STATE OF TENNESSEE
DEPARTMENT OF TRANSPORTATION
BUREAU OF ENGINEERING

I-65 INTERCHANGE AT BUCKNER ROAD
IN SPRING HILL (DESIGN-BUILD)

REV. 09/14/20: REVISED INDEX OF SHEETS.

TYPE	YEAR	PROJECT NO.	SHEET NO.
FUNCT.	2020		3B

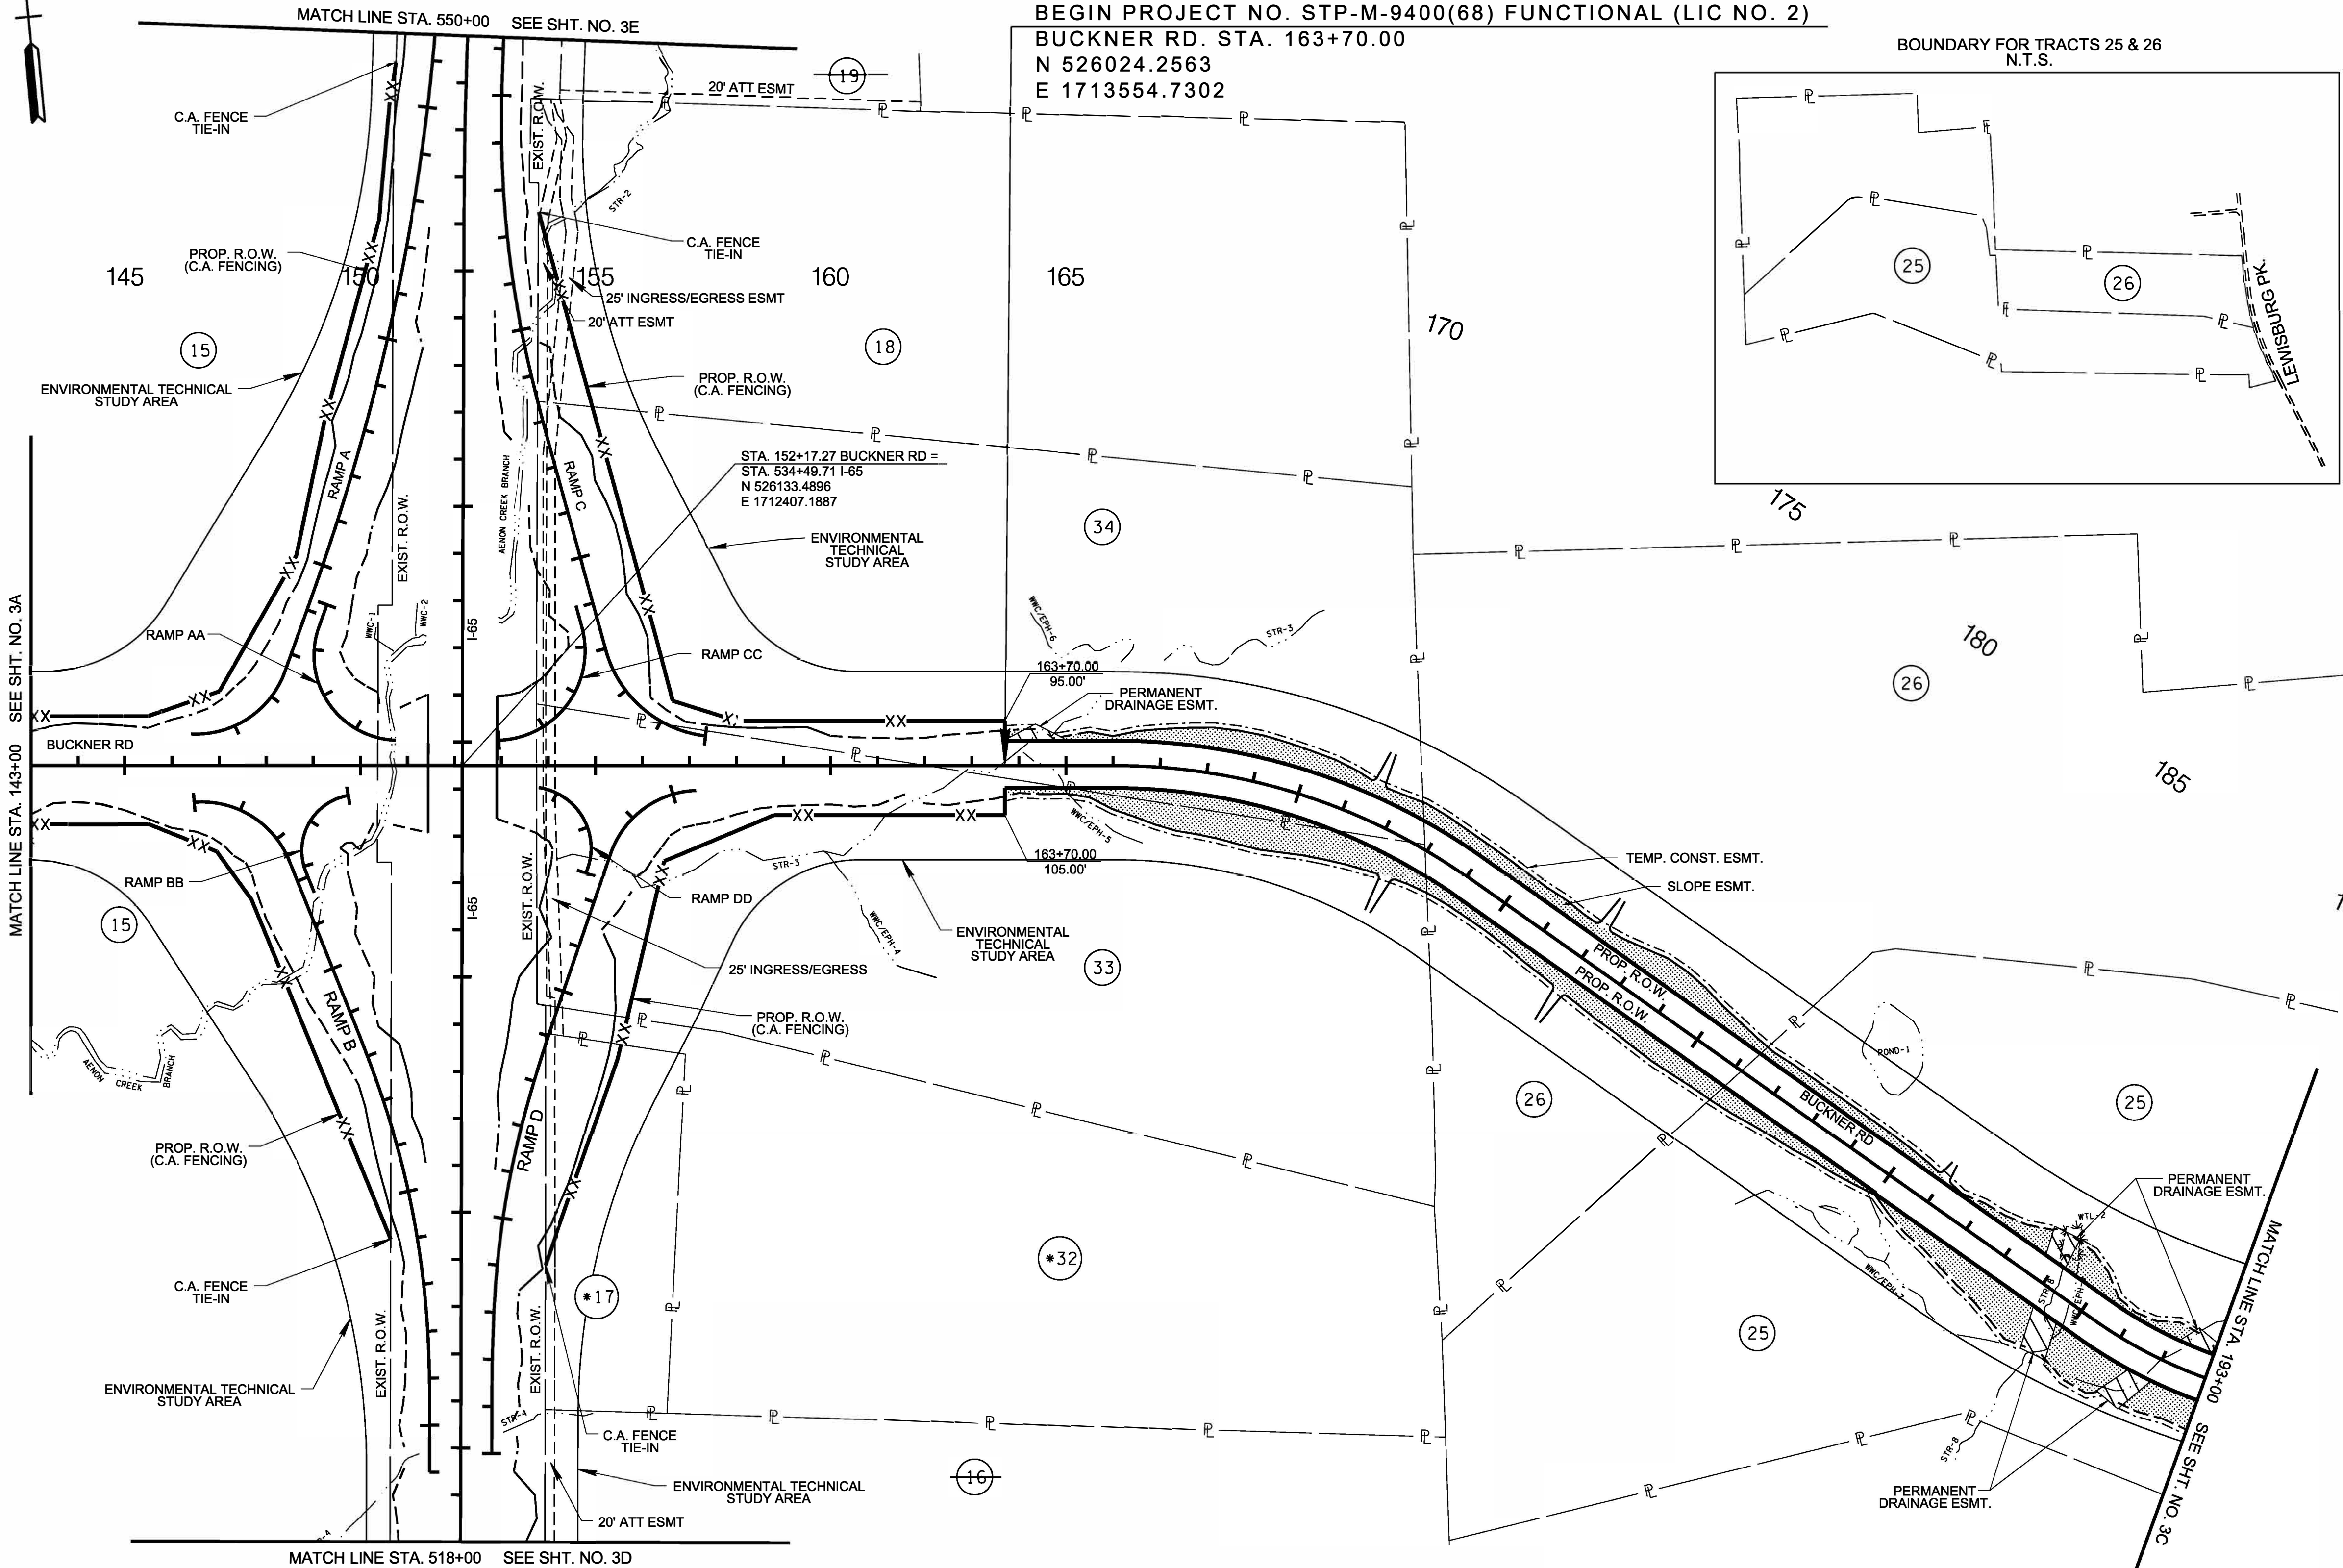
REV. 09/14/20: UPDATED TRACT NO. 18, AND ADDED TRACT NO.'S 32, 33, & 34. REVISED PROP. R.O.W. (C.A. FENCING) ALONG RAMP A.
REV. 10/12/20: ADDED NOTE TO PROVIDE ACCESS ROAD TO TRACT NO.'S 17 AND 32.

* DESIGN BUILDER SHALL PROVIDE AN ACCESS ROAD TO PROVIDE ACCESS TO TRACT NO.'S 17 AND 32. SEE SECTION 3 OF THE RFP FOR FURTHER DETAILS.

TYPE	YEAR	PROJECT NO.	SHEET NO.
FUNCT.	2020		3D

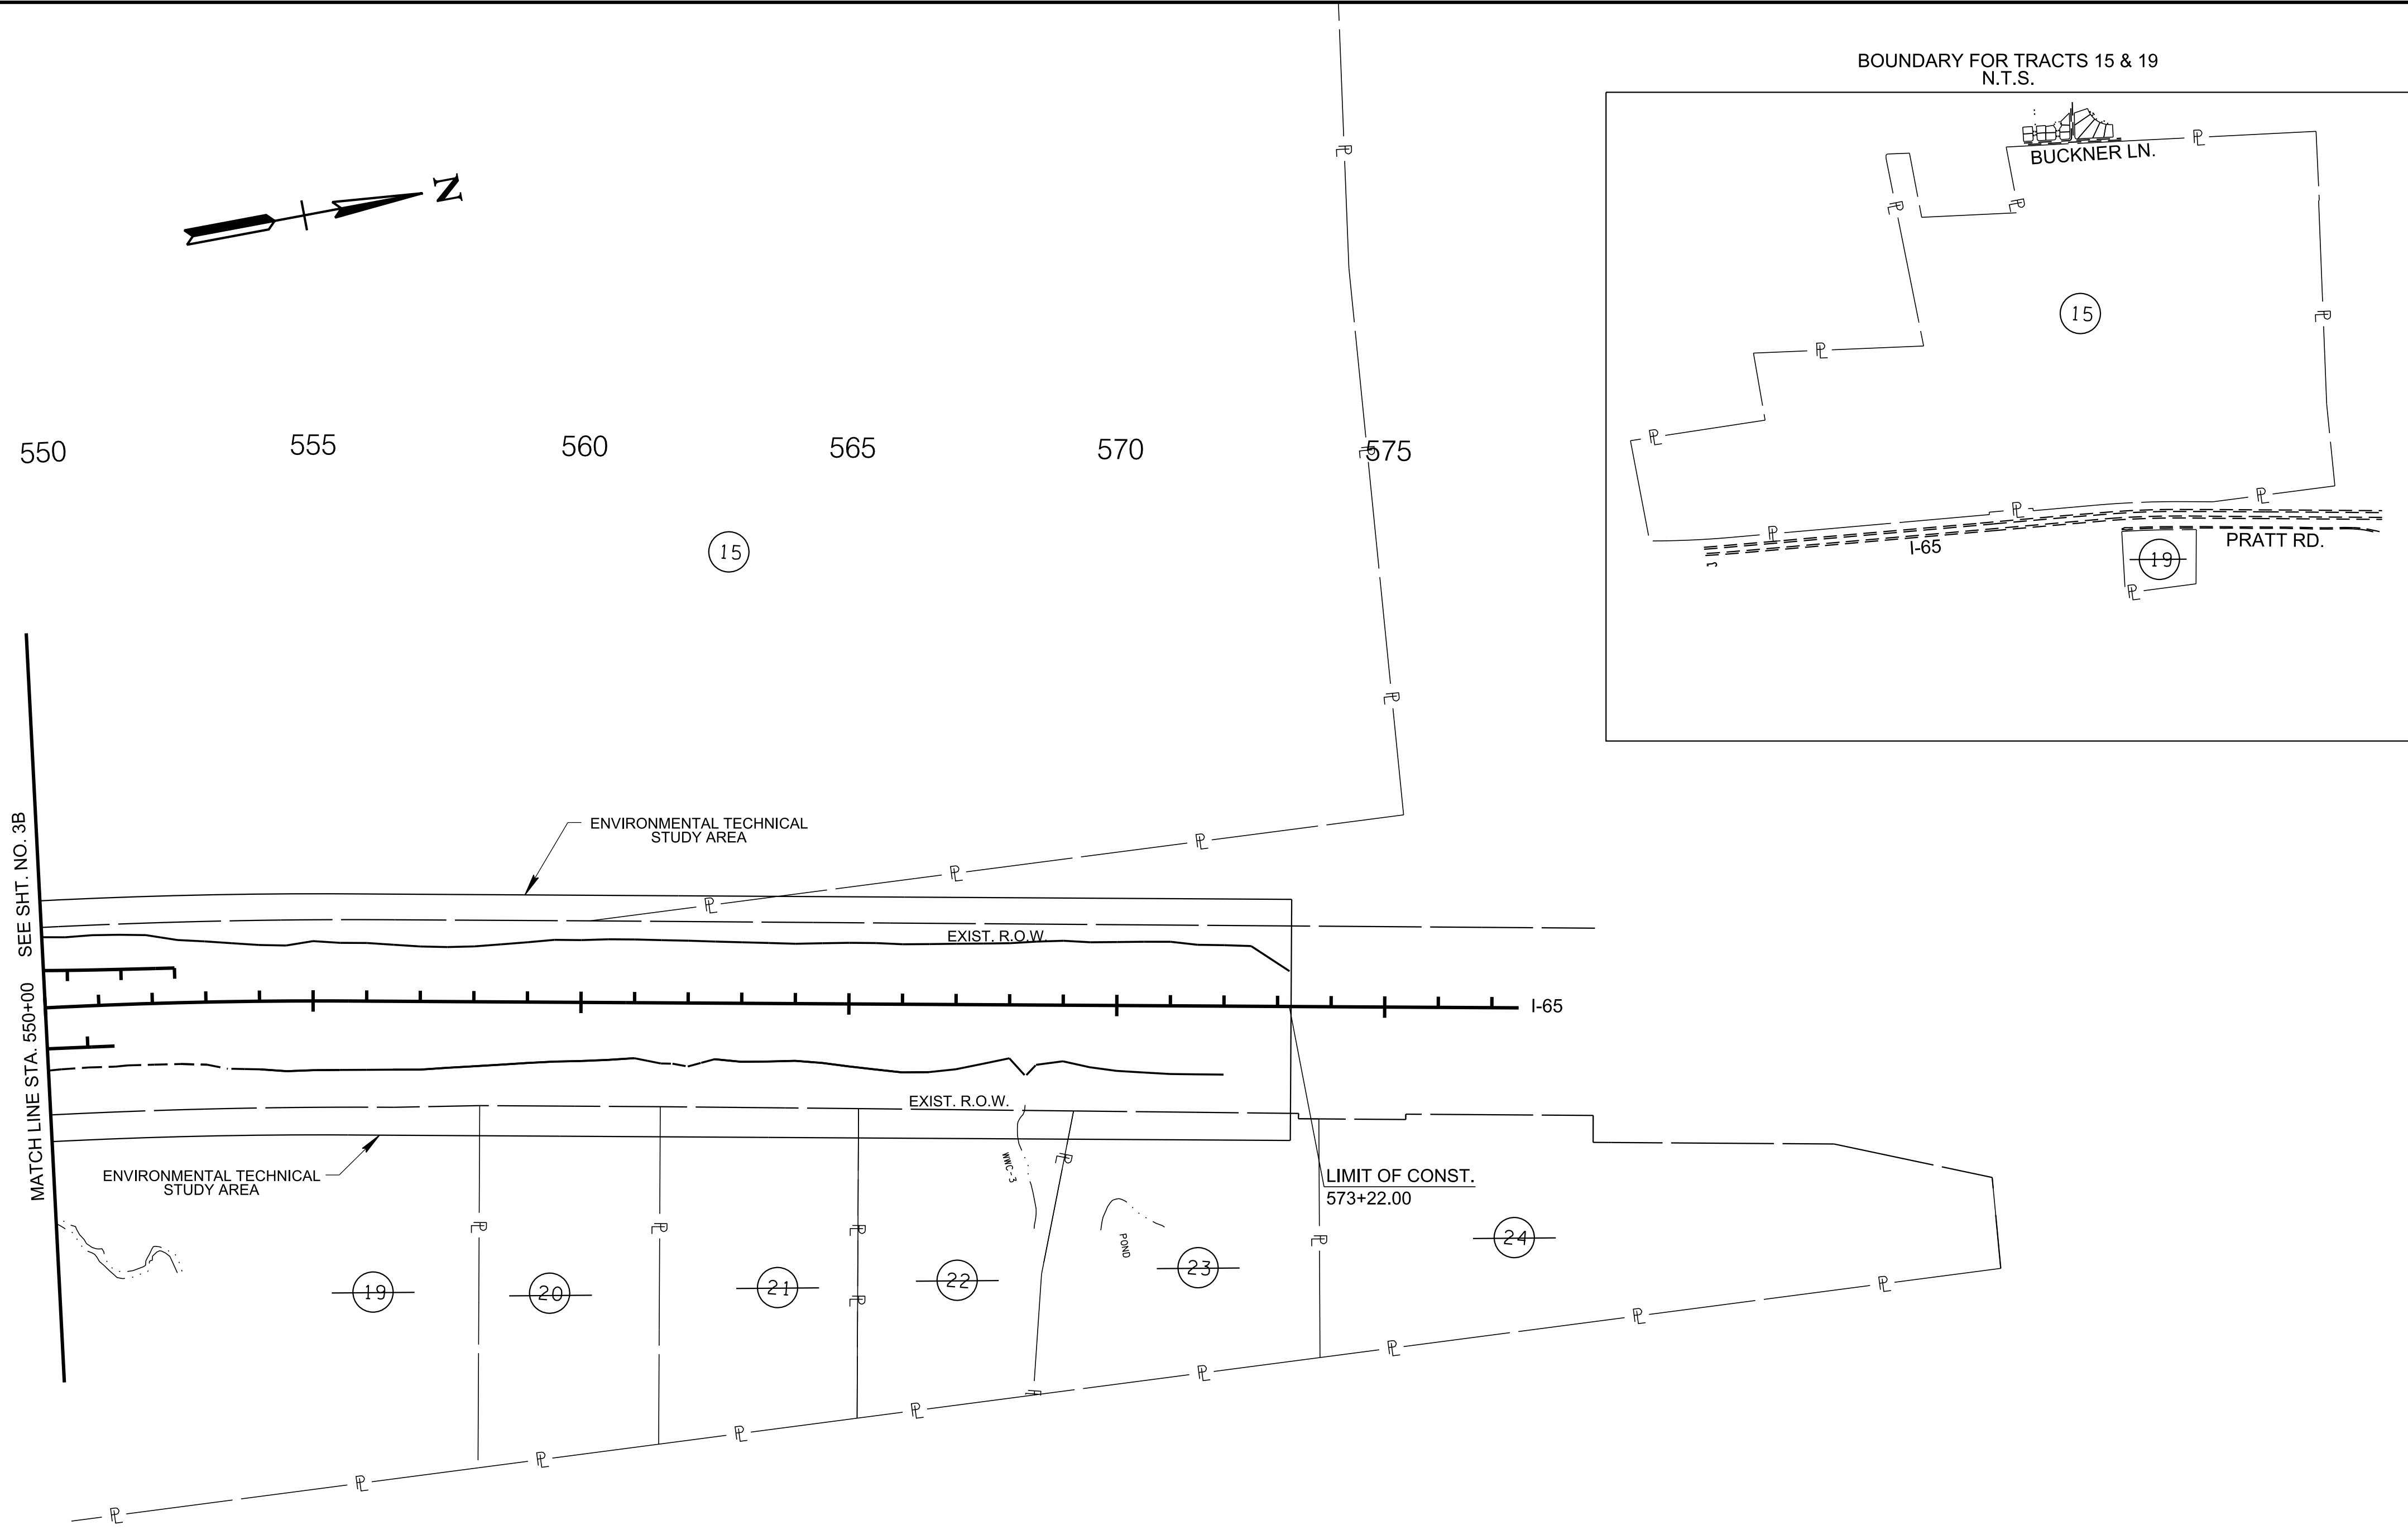
REV. 09/14/20: REVISED LIMIT OF CONSTRUCTION AND ADDED ADDITIONAL ENVIRONMENTAL TECHNICAL STUDY AREA.

TYPE	YEAR	PROJECT NO.	SHEET NO.
FUNCT.	2020		5

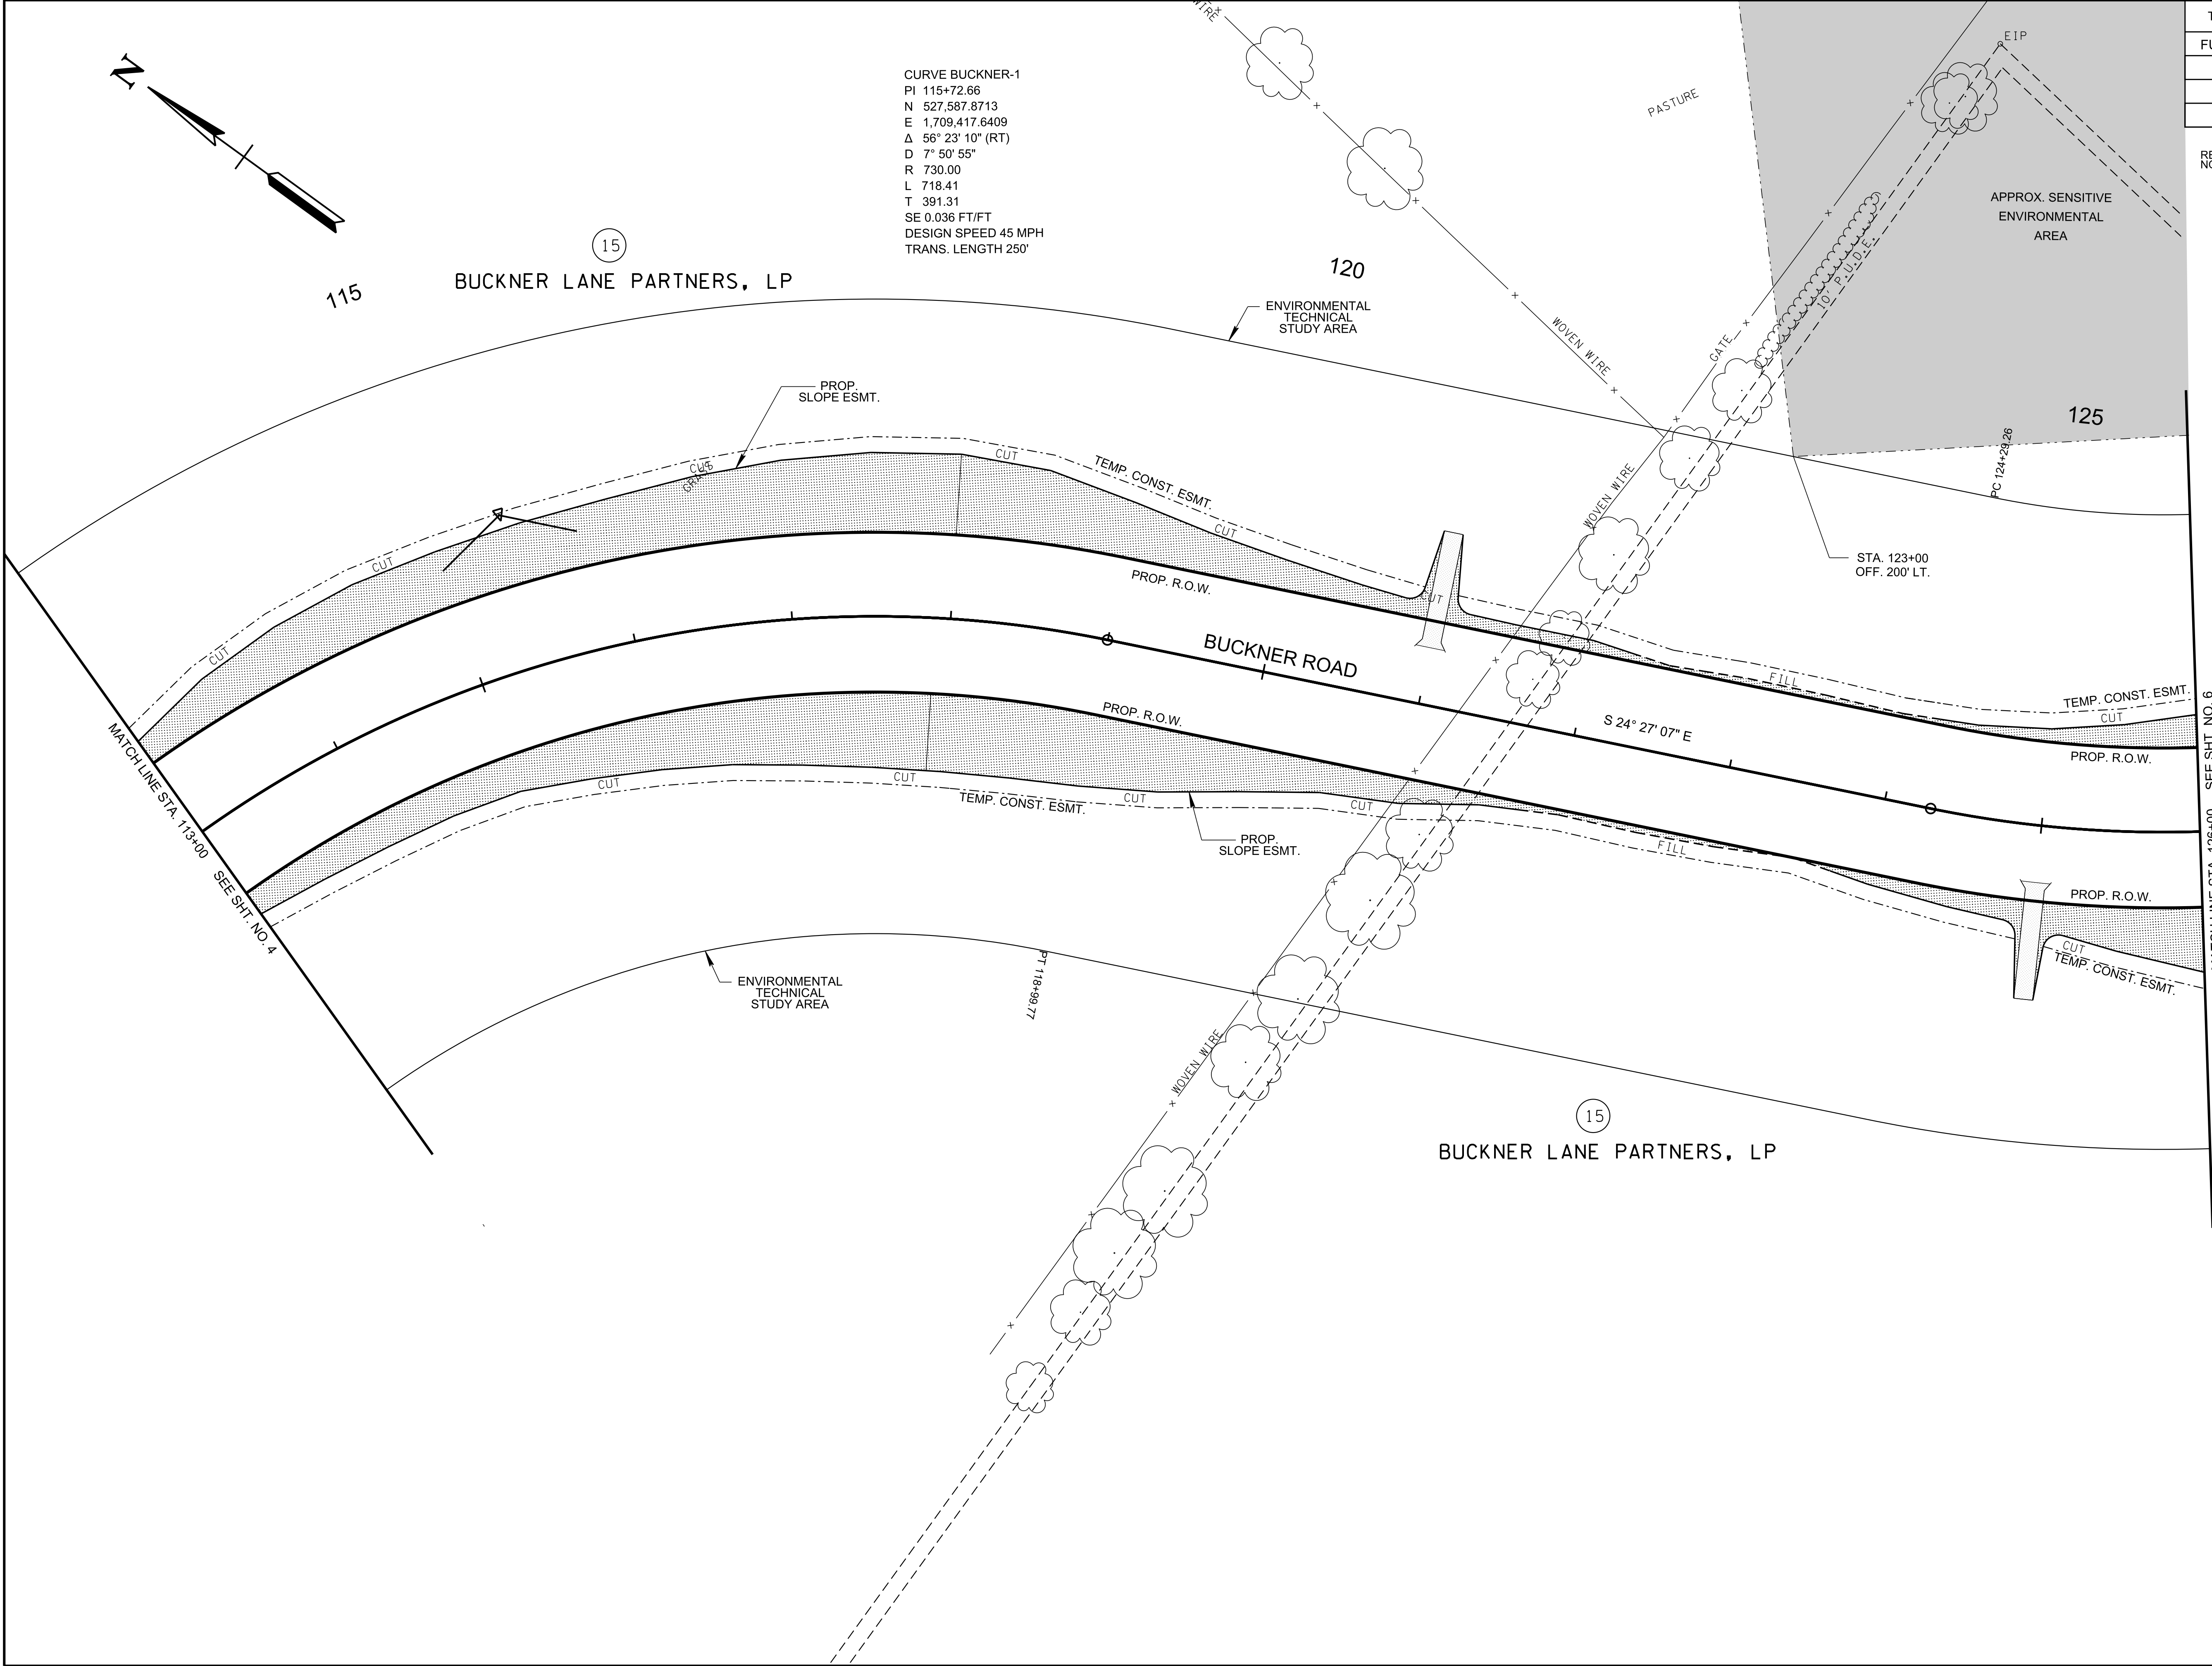
REV. 09/14/20: ADDED FIELD ENTRANCES TO TRACT NO. 15.
